P 30540

SEWAGE DISPOSAL SYSTEM

MARYLAND STATE DEPARTMENT OF HEALTH

SUBDIVISION _____ ROAD 8037 Murphy Road LOT 5

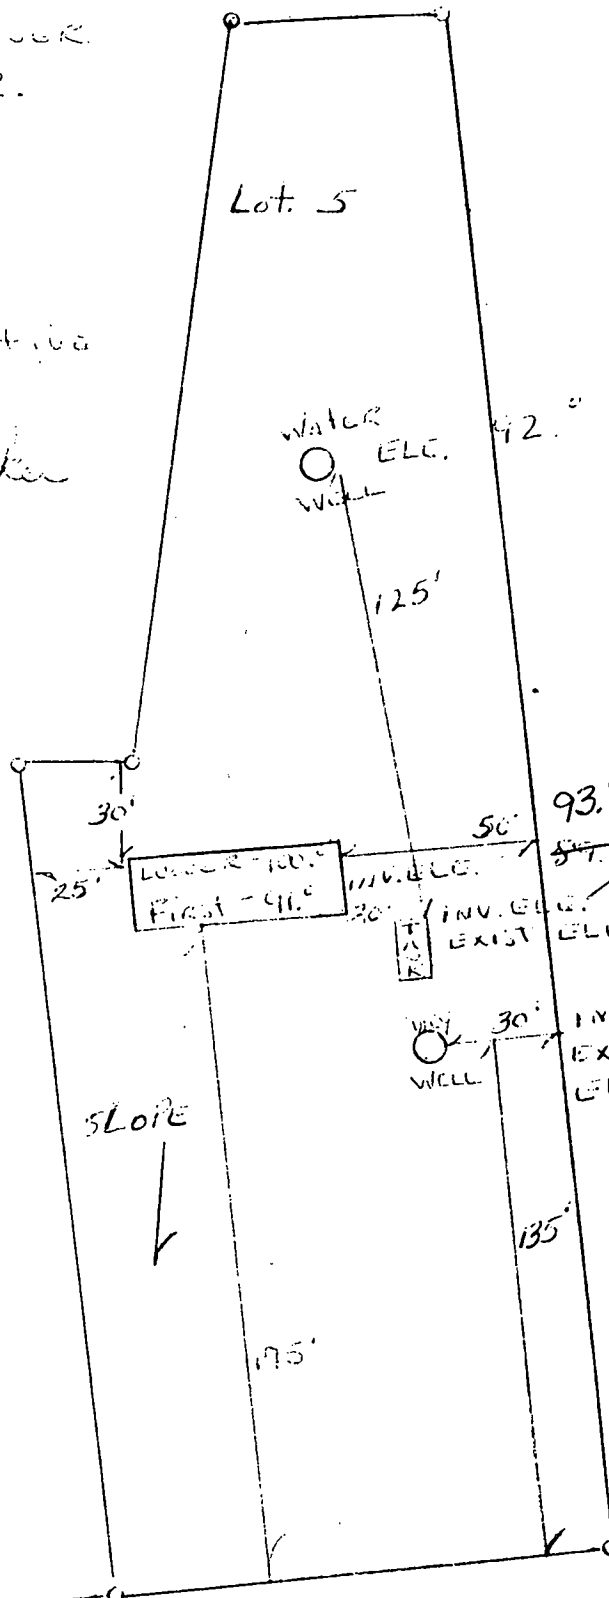
9/7/79 Hold not correct house
plans C.B.S.

insert L.D.W. to be 4' below orig
grade.

Unconnected
92.6' show

90.5' C.B.S.

9/10/79
Changed elevation
per telephone
call from Mr.
Walker. /hr

Ok for dry well and trench to make up additional sidewall area. 5 ft. earth buffer between dry well and trench. Run trench on contour.
